Title   **CRs (Rel-4 and Rel-5 Category A) to TS 25.104 & TS 25.141 on "BS IPDL requirement & test"**

Source   **TSG RAN WG4**

RAN4 Tdoc	Spec	CR	R	Cat	Rel	Curr Ver	Title	Work Item
R4-021687	25.104	159	1	F	Rel-4	4.5.0	BS IPDL requirement	TEI4
R4-021688	25.104	160	1	A	Rel-5	5.4.0	BS IPDL requirement	TEI4
R4-021689	25.141	255	1	F	Rel-4	4.6.0	BS IPDL test	TEI4
R4-021690	25.141	256	1	A	Rel-5	5.4.0	BS IPDL test	TEI4

Title: ⌘	BS IPDL requirement	
Source: ⌘	RAN WG4	
Work item code:⌘	TEI4	***Date:*** ⌘ 26/11/2002

Figure 6.1A: IPDL Time Mask

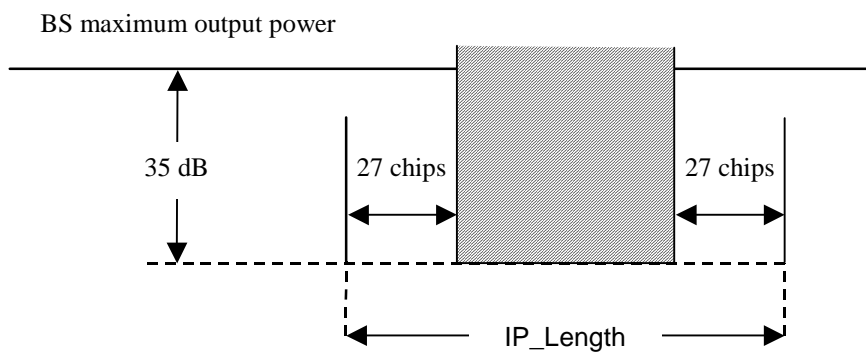
Reason for change: ⌘	BS supporting IPDL shall be able to interrupt all transmission signals in the downlink during a short period. Currently no RF requirement is defined for that feature.
Summary of change:⌘	A new section for BS IPDL requirement is added. The requirement is defined in terms of time mask.
Consequences if not approved: ⌘	Node B requirements to support OTDOA-IPDL based UE positionning are ambiguous. **Isolated Impact Analysis:** This correction has no impact on Node B-UE interworking.

The mean power measured over a period starting 27 chips after the beginning of the IPDL period and ending 27 chips before the expiration of the IPDL period shall be equal to or less than

BS maximum output power – 35 dB;

see also Figure 6.1A.

Figure 6.1A: IPDL Time Mask

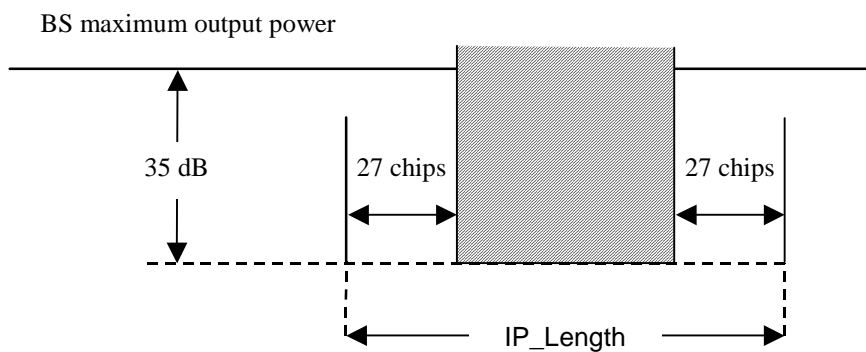
Reason for change:	⌘	BS supporting IPDL shall be able to interrupt all transmission signals in the downlink during a short period. Currently no RF requirement is defined for that feature.
Summary of change:⌘		A new section for BS IPDL requirement is added. The requirement is defined in terms of time mask.
Consequences if not approved:	⌘	Node B requirements to support OTDOA-IPDL based UE positionning are ambiguous. **Isolated Impact Analysis:** This correction has no impact on Node B-UE interworking.

The mean power measured over a period starting 27 chips after the beginning of the IPDL period and ending 27 chips before the expiration of the IPDL period shall be equal to or less than

BS maximum output power – 35 dB;

see also Figure 6.1A.

Figure 6.4: IPDL Time Mask

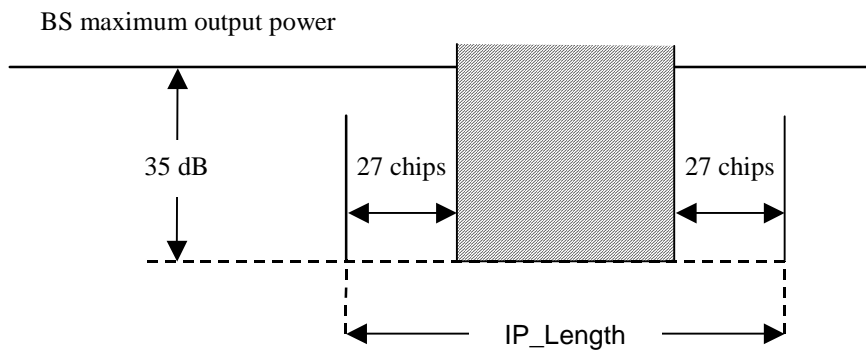
Reason for change: ⌘	BS supporting IPDL shall be able to interrupt all transmission signals in the downlink during a short period. Currently no test is defined for that feature.
Summary of change: ⌘	- new section 6.4.5 for BS IPDL test added - TS 25.214 added to references - BS IPDL test added in tables 4.1 , 4.1.C, F.1 and G.1 - IPDL test added to test model 1 list
Consequences if not approved: ⌘	There will be no test for IPDL requirements. **Isolated Impact Analysis:** The proposed correction has no impact on NodeB-UE interworking since it is a correction to a Node B test specification.

The mean power measured over a period starting 27 chips after the beginning of the IPDL period and ending 27 chips before the expiration of the IPDL period shall be equal to or less than

BS maximum output power – 35 dB;

see also Figure 6.4

BS maximum output power – 34.3 dB.

Figure 6.4: IPDL Time Mask

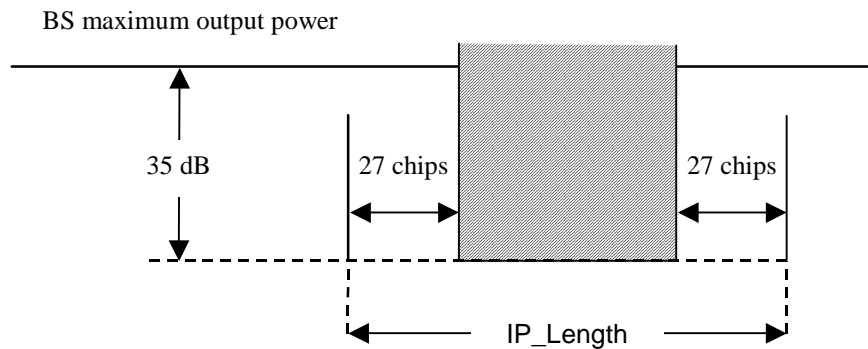
Reason for change: ⌘	BS supporting IPDL shall be able to interrupt all transmission signals in the downlink during a short period. Currently no test is defined for that feature.
Summary of change: ⌘	- new section 6.4.5 for BS IPDL test added - TS 25.214 added to references - BS IPDL test added in tables 4.1 , 4.1.C, F.1 and G.1 - IPDL test added to test model 1 list
Consequences if not approved: ⌘	There will be no test for IPDL requirements. **Isolated Impact Analysis:** The proposed correction has no impact on NodeB-UE interworking since it is a correction to a Node B test specification.

The mean power measured over a period starting 27 chips after the beginning of the IPDL period and ending 27 chips before the expiration of the IPDL period shall be equal to or less than

BS maximum output power – 35 dB;

see also Figure 6.4
